SUBJECT: SAFETY RECALL: FRONT AXLE BRAKE HOSE ROUTING

Ref.: **NHTSA # 15V-001**

Service Bulletin No. 420

MODEL	J4500 Series	TYPE	Field Change Program	SECTION/GROUP	1-Front Axle	DATE	March 2, 2015
SUBJECT	FRONT AXLE BRAKE HOSE ROUTING						
CONDITIONS

Figure 7. Clamp mount bracket weld symbols.

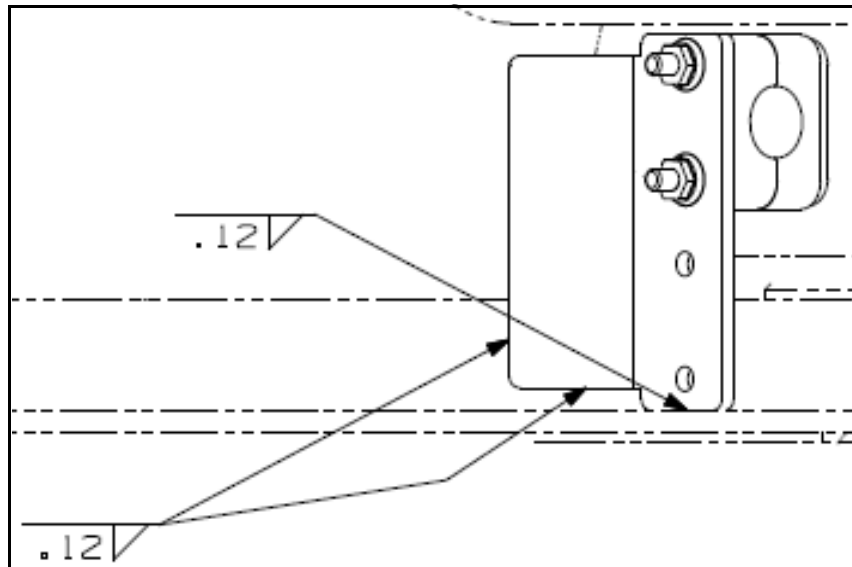
10. Cut and discard the tyrap securing the ABS sensor to the front brake hose assembly. Disconnect the front brake hose assembly from the front axle brake chamber port. Discard the existing front brake hose assembly. Retain the mounting hardware to be re-installed at a later step in this procedure.
11. Position the new clamp mount bracket, p/n 03-53-1618, on the bogie channel as outlined as Item 1 / Figure 8. Mark a chalk outline around the entire bracket. Remove bracket. Repeat step to opposite side.
12. Using a wire brush, thoroughly clean the surface area of dirt or grease from the installation area where the brackets will be welded.
13. Weld the clamp mount bracket according to the weld symbol in Figure 7, using the following method,

14. Repeat Step 13 to opposite side of coach.

SHIELDED METAL ARC WELDING (SMAW)

Stainless Steel - Alloy type, 309L / 1/8 inch, 80A-100A

or,

GAS METAL ARC WELDING (GMAW)

Stainless Steel - Alloy type, 309L / 0.035 Dia., 300-350 IPM, 23V-25V.

Figure 8. Clamp mount bracket location.

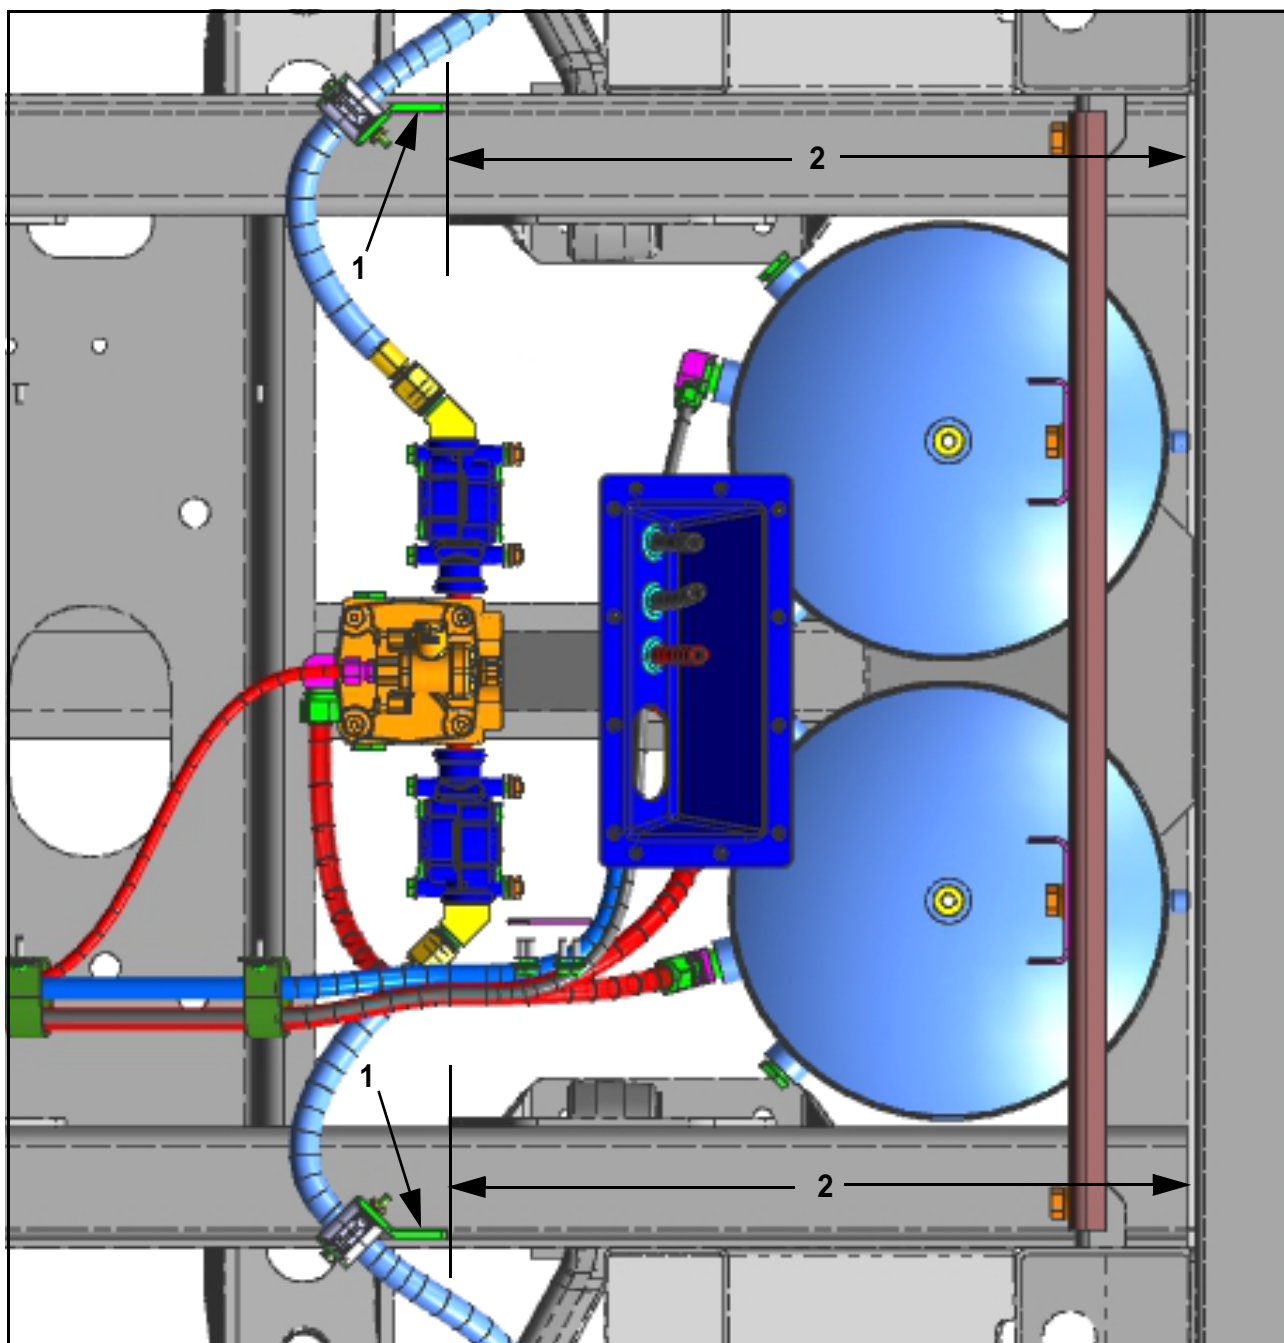
25. Route the front brake hose assembly to the clamp mount bracket welded to the bogie channel. Remove and retain clamp assembly and the existing mounting hardware from the old mounting location (replaced by the new welded clamp mount bracket). Mount the clamp assembly and front brake hose assembly to the clamp mount bracket. Tighten clamp to secure the front brake hose assembly in position (refer to Figure 8).

Item	Figure 8 Description
1	clamp mount bracket, p/n 03-53-1618
2	20.75 inch

Figure 9.

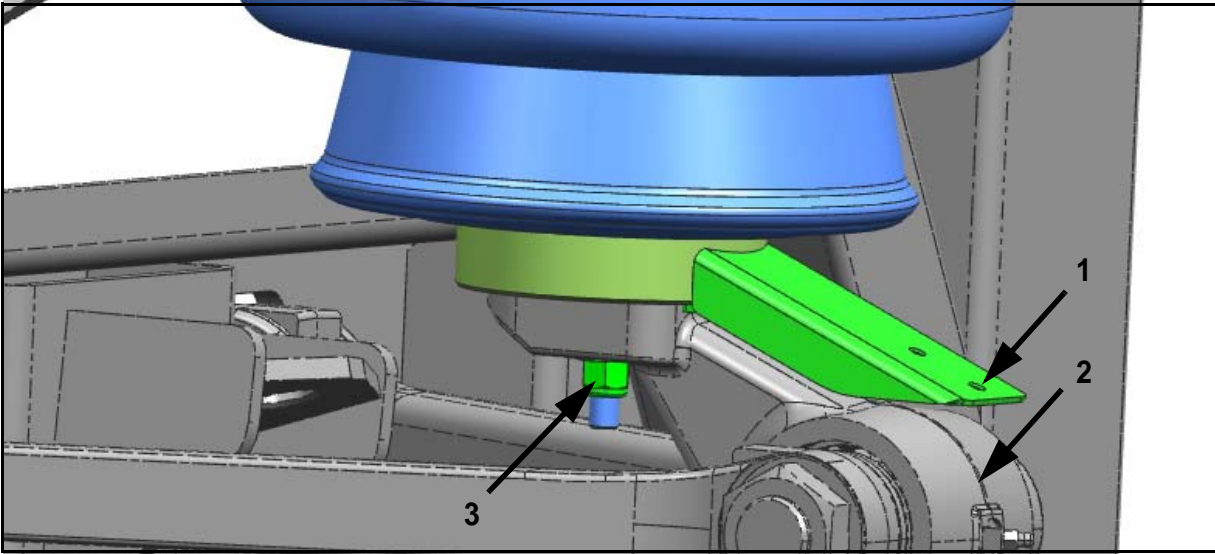
15. Using a square or straight edge, ensure that the geometry of the first brake hose clamp is parallel to the center of the kingpin (refer to Figures 9 and 11)

If adjustment is required, loosen (do not remove nut from stud) the nylock nut on the airspring assembly and orient to achieve the brake hose clamp parallel to the center of the kingpin (refer to Figure 9). Torque nylock nut to 40-50 ft-lbs.

Item	Figure 9 Description
1	brake hose clamp holes
2	center of kingpin
3	nylock nut

Figure 10. Front brake line gauge location.

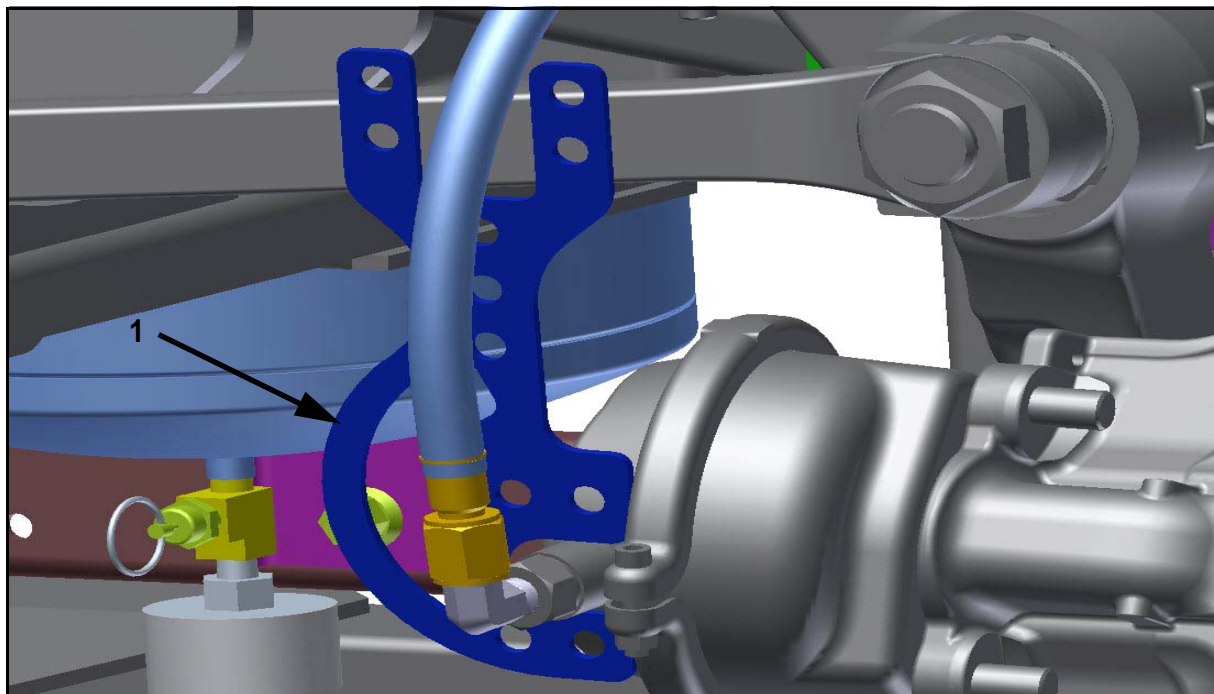
16. Apply drops of lubricant to the swivel section on the new front brake hose assembly, p/n 04-20-1726.
17. Orient and connect the new front brake hose assembly to the 90 degree fitting on the front brake chamber as shown in Figure 10.
18. Starting at the front brake chamber, route the front brake hose assembly to the first brake hose bracket (refer to Figure 11). Using the existing mounting hardware, mount (fingertight) the clamp assembly to the brake hose bracket.
19. Orient the front brake line gauge, p/n 20-04-0028, against the front brake chamber clamp as shown in Figure 10. Center the hose routing with the upper opening of the front brake line gauge and tighten the swivel nut to secure in position, ensuring that there is no twist or flex at any point throughout the routing. Torque nut to 56-60 ft-lbs.

Item	Figure 10 Description
1	front brake line gauge

Figure 11.

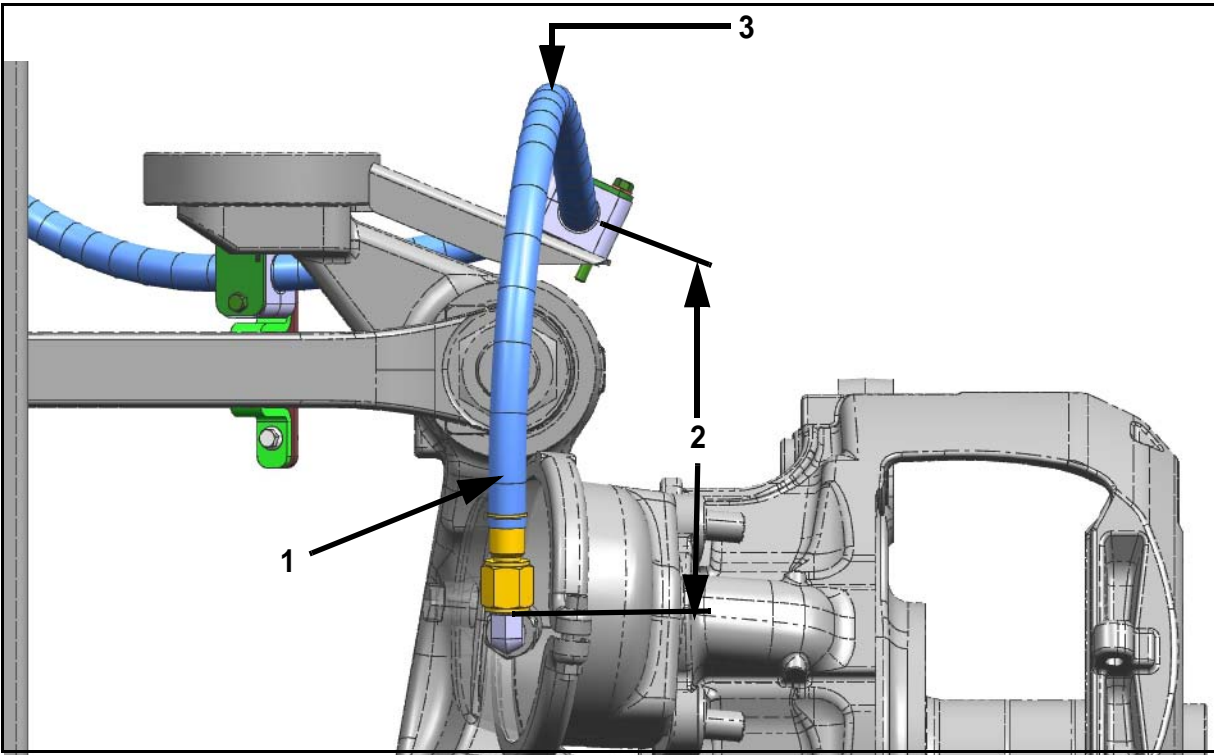
20. Using a measuring tape, ensure that the front brake hose length is the 22.00 inches between the bottom of the swivel fitting to the inside face of the clamp as shown in Figure 11. Tighten clamp to secure in position.

Item	Figure 11 Description
1	front brake hose assembly, p/n 04-20-1726
2	22.00 inch of hose length from bottom of swivel fitting to inside face of clamp
3	measurement to be taken along the top section of the front brake hose assembly

Figure 12.

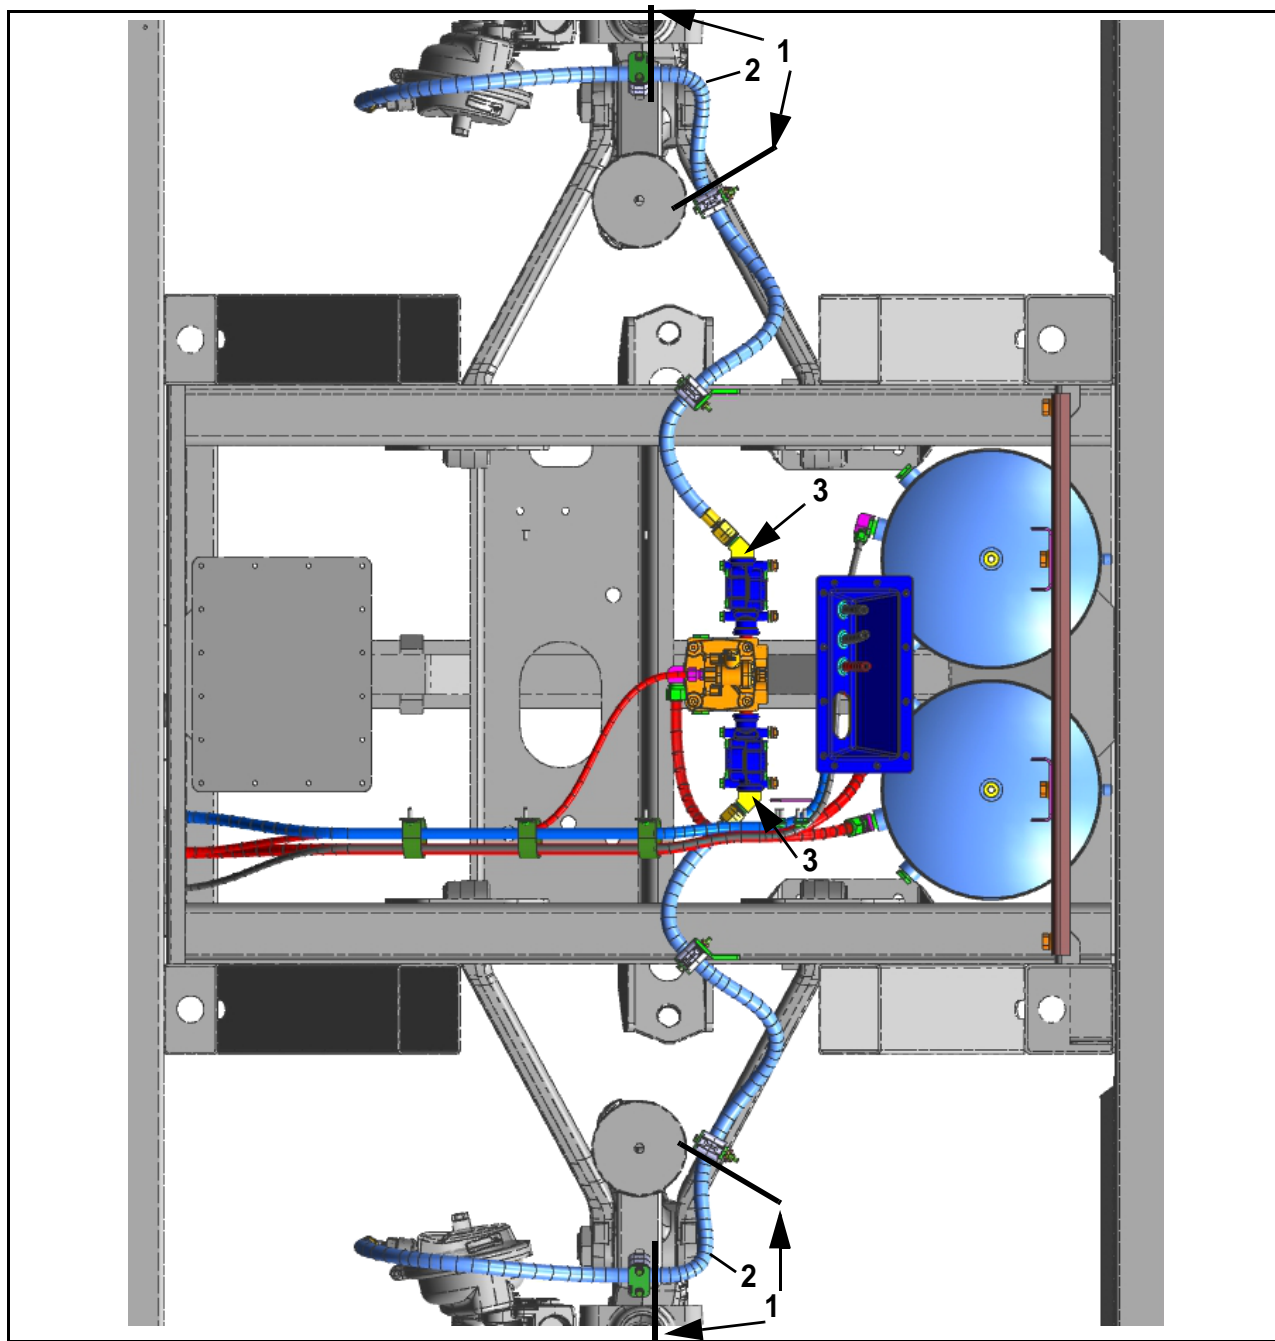
21. Route the front brake hose assembly to the next (second) brake hose bracket. Using the existing mounting hardware, mount the clamp assembly to the brake hose bracket.
22. Using a measuring tape, ensure that the front brake hose assembly routing length is the 8.00 to 8.25 inches of hose length from face to face of the clamps while maintaining a minimum bend radius of 2.25 inches as shown in Figure 12.
23. Tighten clamps to secure in position.

26. Using two (2) wrenches, remove and discard the straight fitting from the front brake module. Apply a pair of drops of sealant to the NPT threads of the 45 degree fitting, p/n 19-10-1956. Install the 45 degree fitting, fingertight, in the front brake module as shown in Figure 12. Using two (2) wrenches, tighten the fitting 2.50 turns. Tighten fitting to orientation shown in Figure 12.

Item	Figure 12 Description
1	8.00 to 8.25 inches of hose length from face to face of clamps
2	measurement to be taken along the outboard section of the front brake hose assembly
3	45 degree fitting, p/n 19-10-1956

Figure 13.

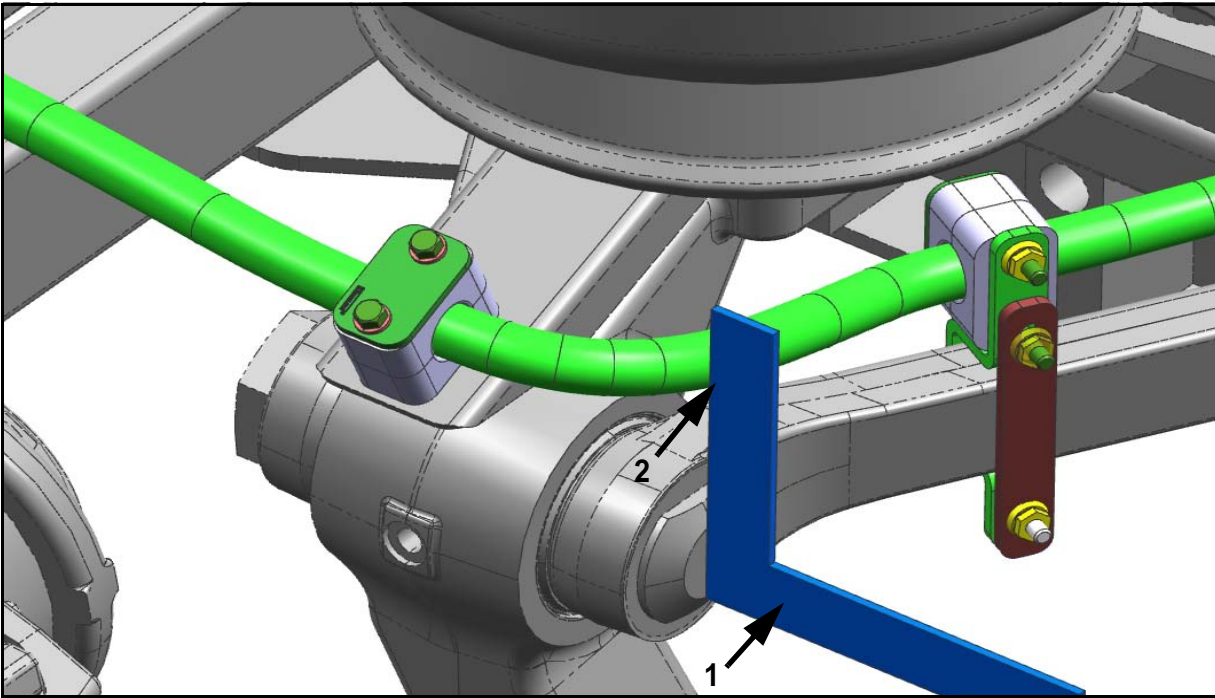
24. Position a square across the face of the suspension arm bolt head (refer to Figure 13). Using a measuring tape, ensure that there is a minimum clearance of 0.06 inch between the edge of the front brake hose assembly and the edge of the square.

Item	Figure 13 Description
1	position square across the face of the suspension arm bolt head
2	minimum clearance of 0.06 inch between the edge of the front brake hose assembly and the edge of the square

Figure 14.

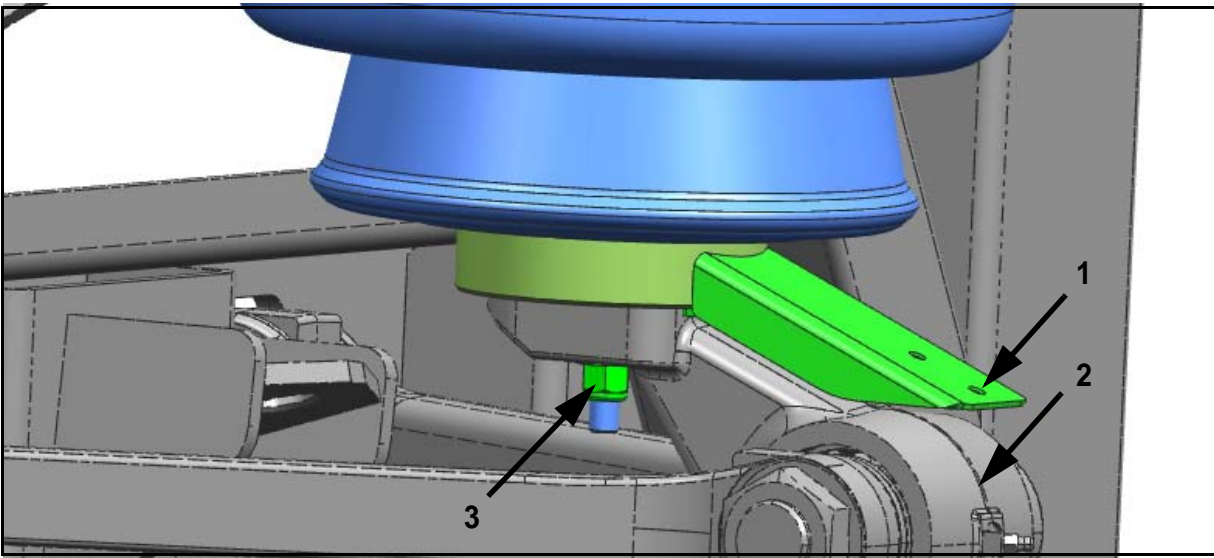
35. Cut and discard the tyrap securing the ABS sensor to the front brake hose assembly.
36. Disconnect the front brake hose assembly from the front axle brake chamber port. Discard the existing front brake hose assembly. Retain the mounting hardware to be re-installed at a later step in this procedure.
37. Using a square or straight edge, ensure that the geometry of the first brake hose clamp is parallel to the center of the kingpin (refer to Figures 14 and 16).

If adjustment is required, loosen (do not remove nut from stud) the nylock nut on the airspring assembly and orient to achieve the brake hose clamp parallel to the center of the kingpin (refer to Figure 14). Torque nylock nut to 40-50 ft-lbs.

Item	Figure 14 Description
1	brake hose clamp holes
2	center of kingpin
3	nylock nut

Figure 15.

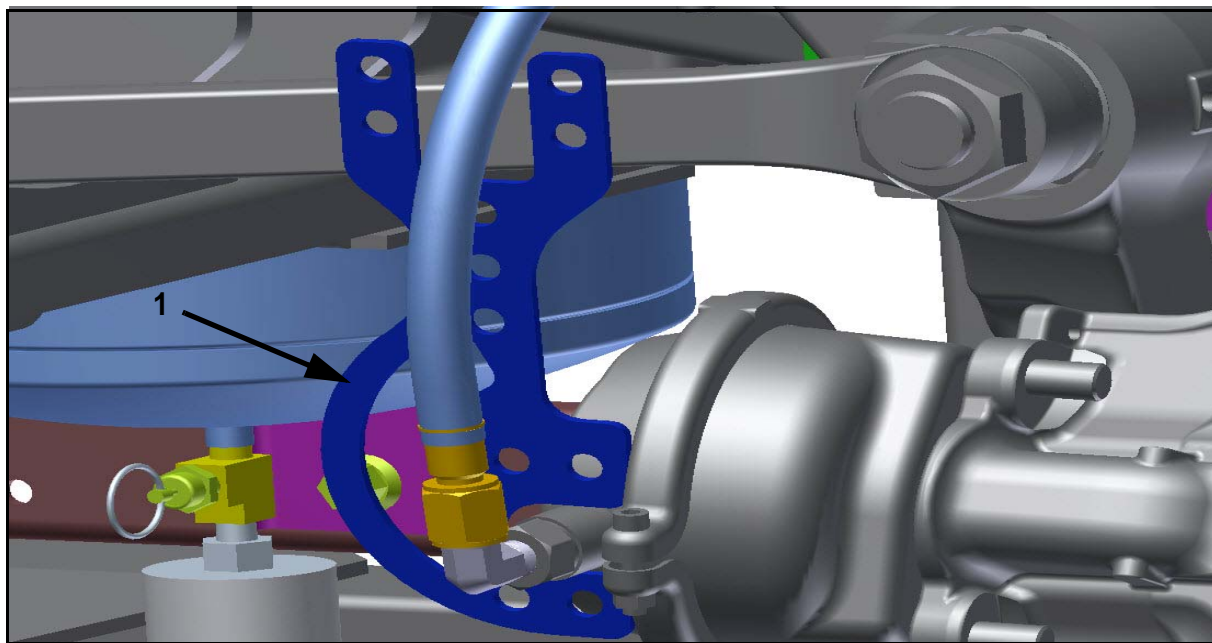
38. Apply a pair of drops of lubricant to the swivel section on the new front brake hose assembly, p/n 04-20-1726.
39. Orient and connect the new front brake hose assembly to the 90 degree fitting on the front brake chamber as shown in Figure 15.
40. Starting at the front brake chamber, route the front brake hose assembly to the first brake hose bracket (refer to Figure 16). Using the existing mounting hardware, mount (fingertight) the clamp assembly to the brake hose bracket.
41. Orient the front brake line gauge, p/n 20-04-0028, against the front brake chamber clamp as shown in Figure 15. Center the hose routing with the upper opening of the brake line alignment tool and tighten the swivel nut to secure in position, ensuring that there is no twist or flex at any point throughout the routing.

Item	Figure 15 Description
1	front brake line gauge
